## **BID ADDENDUM NO. 3**

### **Johnson Student Center**

### **Building Demolition, Increment 1 (Demolition) and Increment 2**

RANCHO SANTIAGO COMMUNITY COLLEGE DISTRICT  
SANTA ANA, CA

A0.02

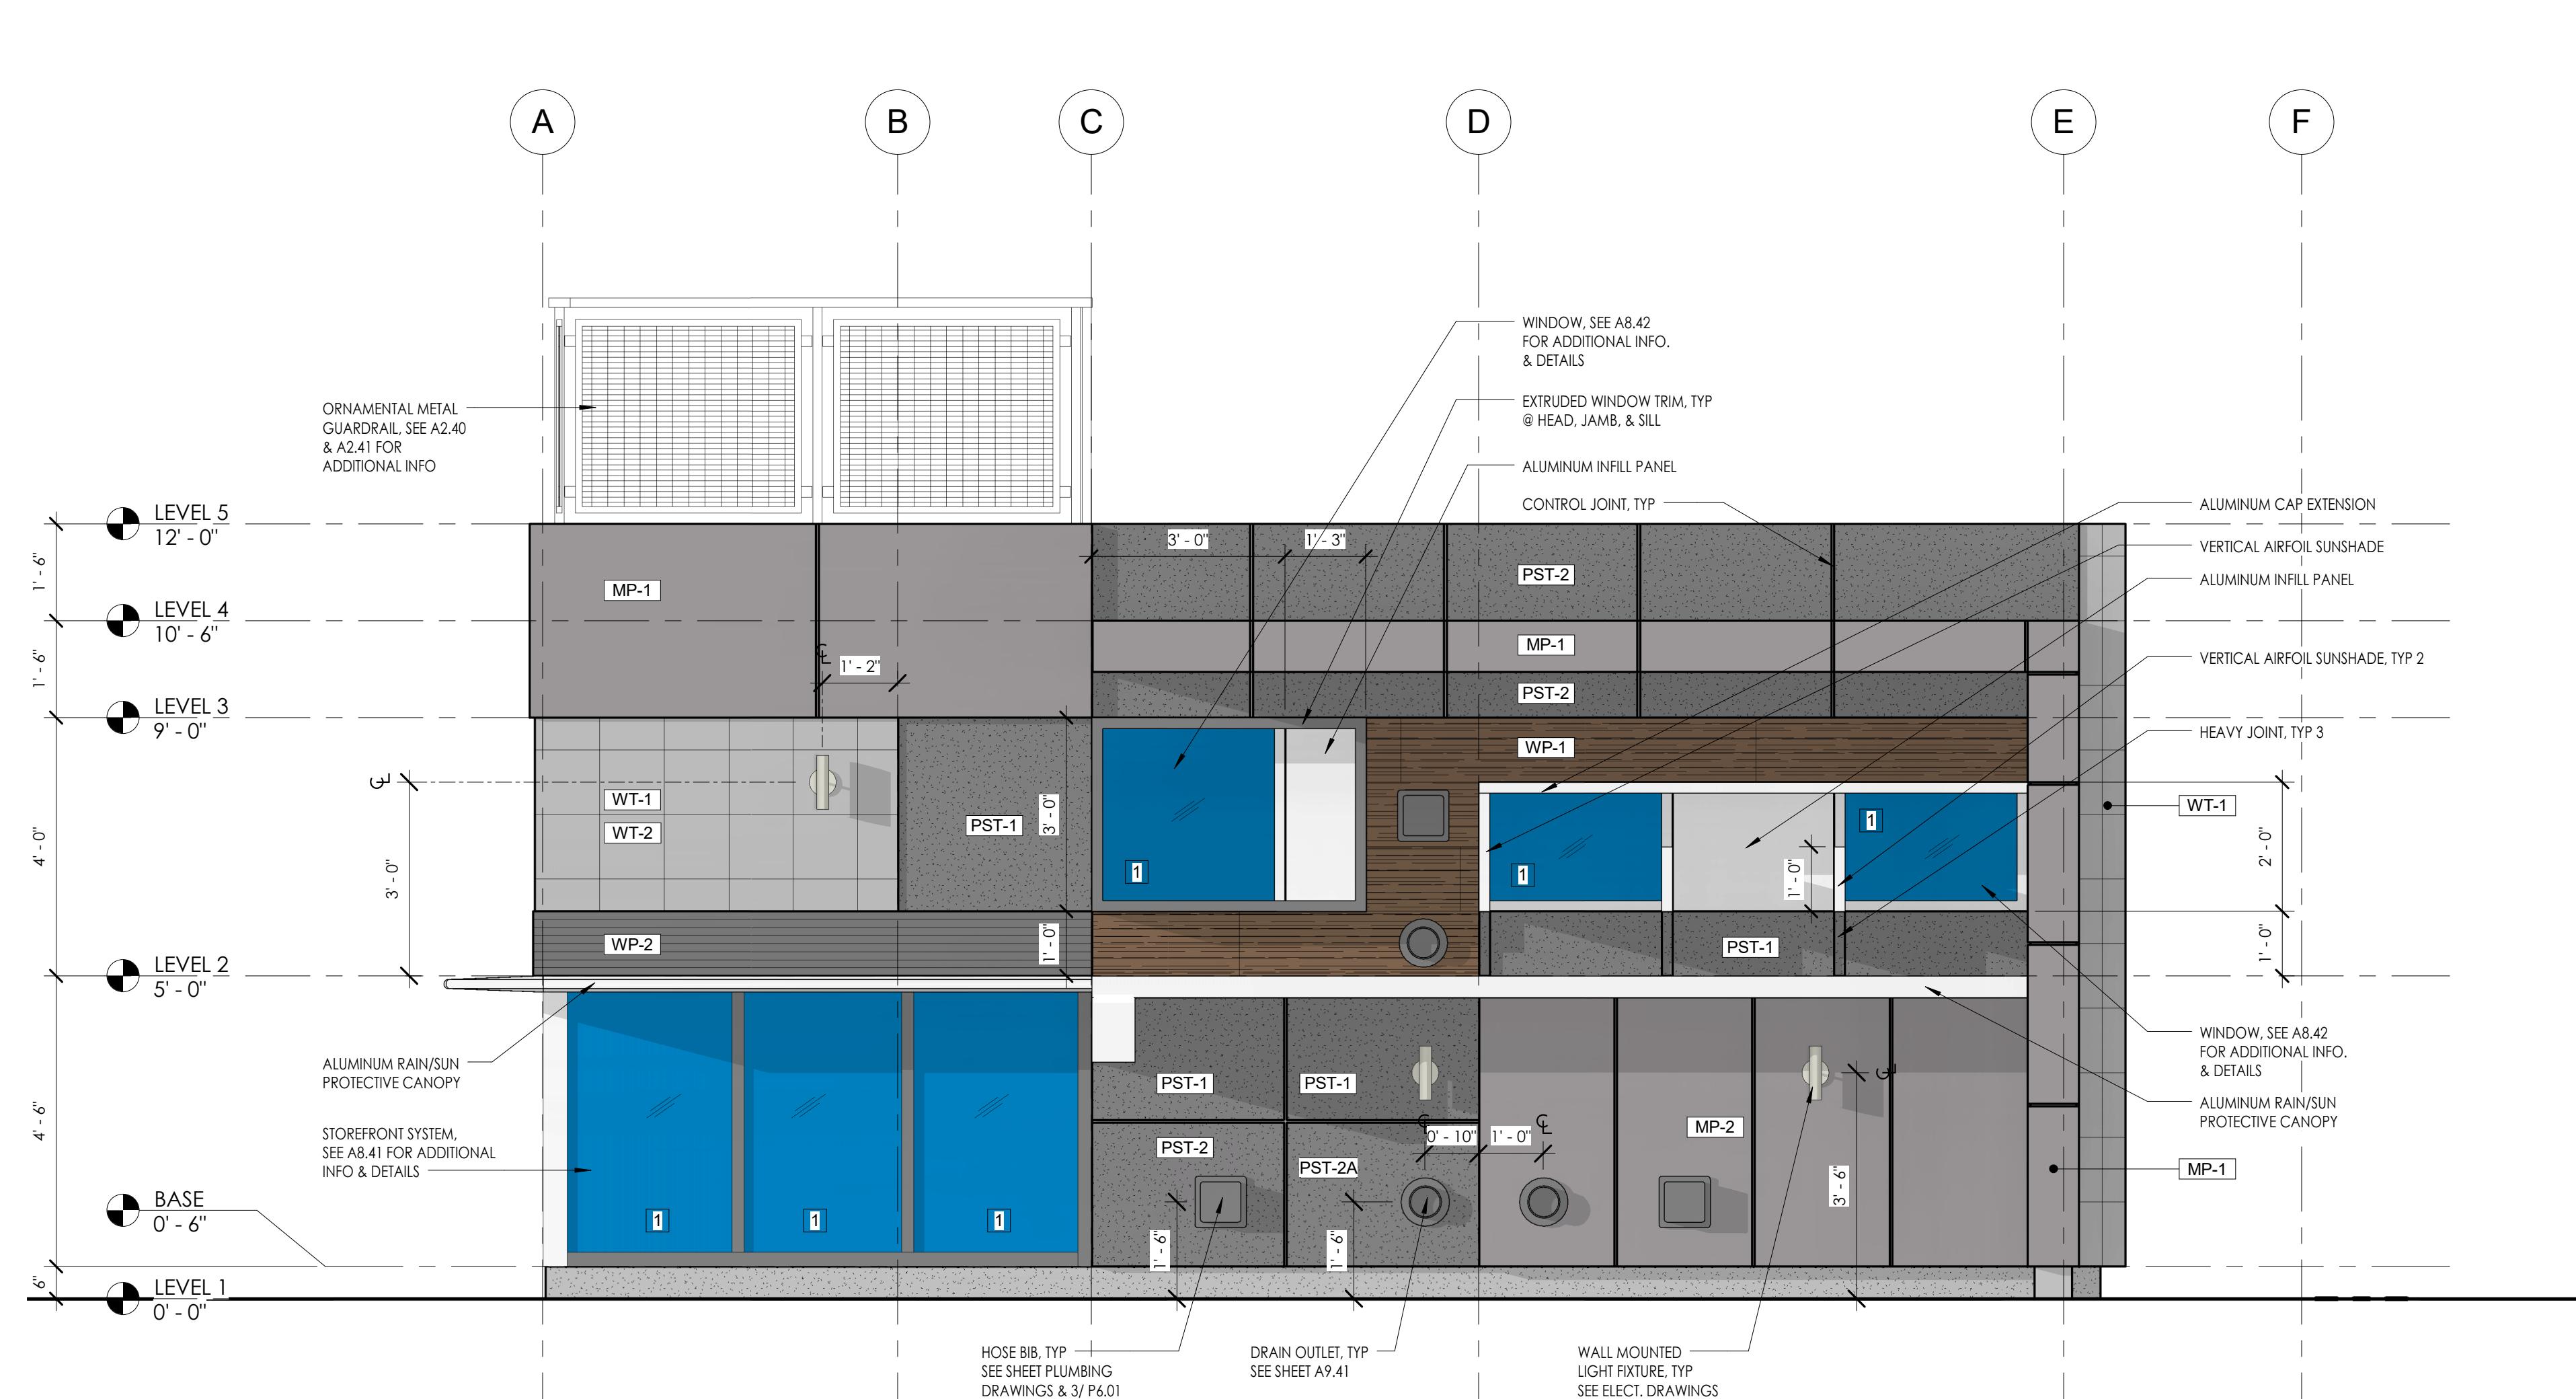
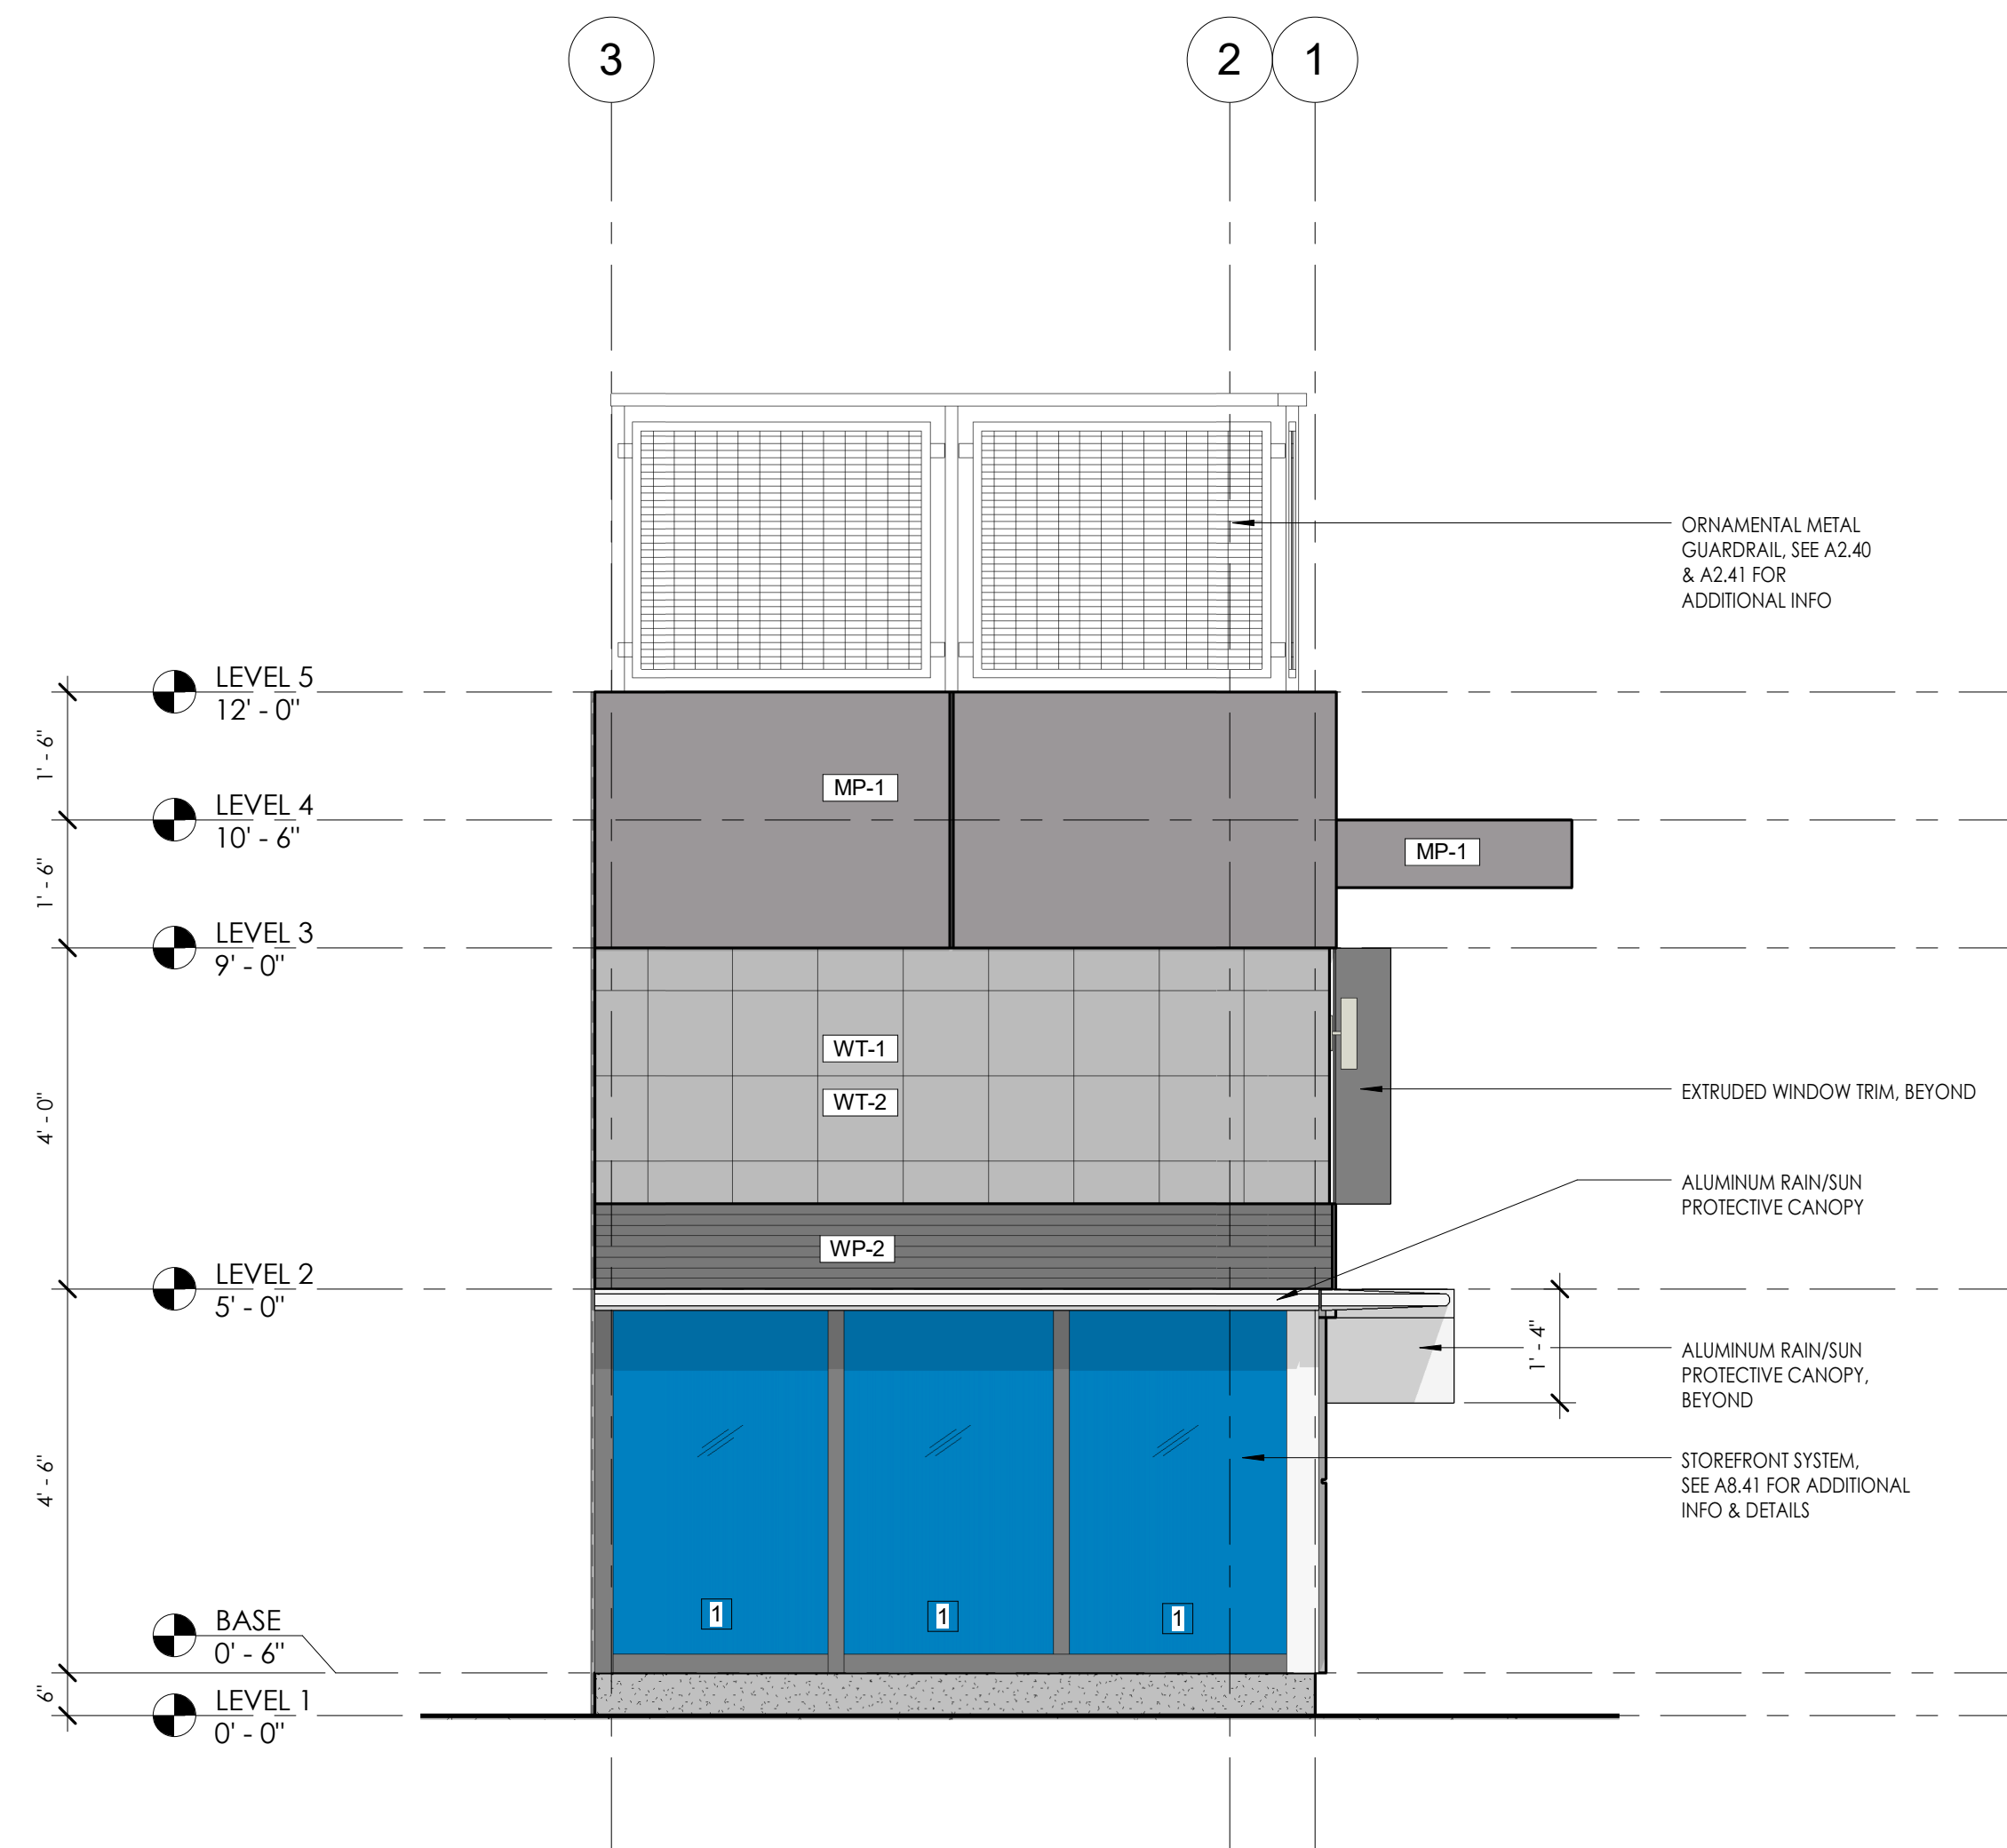
- Increment 2
  - i. General Contractor to provide an Exterior Material Mock-Up, refer to design drawings. Reference new sheets A0.01 and A0.02
- Increment 2
  - i. Added new detail sheet G3.12 (signage details) for monument / site signs.

1. SHEET METAL - SHOP FAB. IS ACCEPTABLE
2. SHEET METAL - TOUCH-UP PAINT REQUIRED FOR MOCKUP
3. CONTRACTOR TO COORDINATE LOCATION OF MOCKUP ON SITE
4. MOCKUP TO BE WORKING MOCKUP AND REVISIONS WILL BE MADE DURING CONSTRUCTION AS NEEDED PER ARCHITECT'S DIRECTION.
5. REFERENCE ISA APPROVED DRAWINGS AND SPECS (A194-11&10) FOR DETAILS AND MATERIAL C.
6. NO STRUCTURAL STEEL. MOCKUP IS INTENDED TO BE FRAMED WITH STEEL STUDS AND IS SELF-SUPPORTING.
7. MOCKUP SHALL BE FRAMED WITH 1 1/2" GA. 6" STUDS @ 12" O.C. U.N.O. REF TO SHEET SA.10 FOR MORE INFO.
8. DETAIL REFERENCES ARE INTENDED TO SHOW MATERIAL TRANSITION AND ASSEMBLY REFER TO SHEET A0.01 & A0.02 FOR DIMENSIONS.
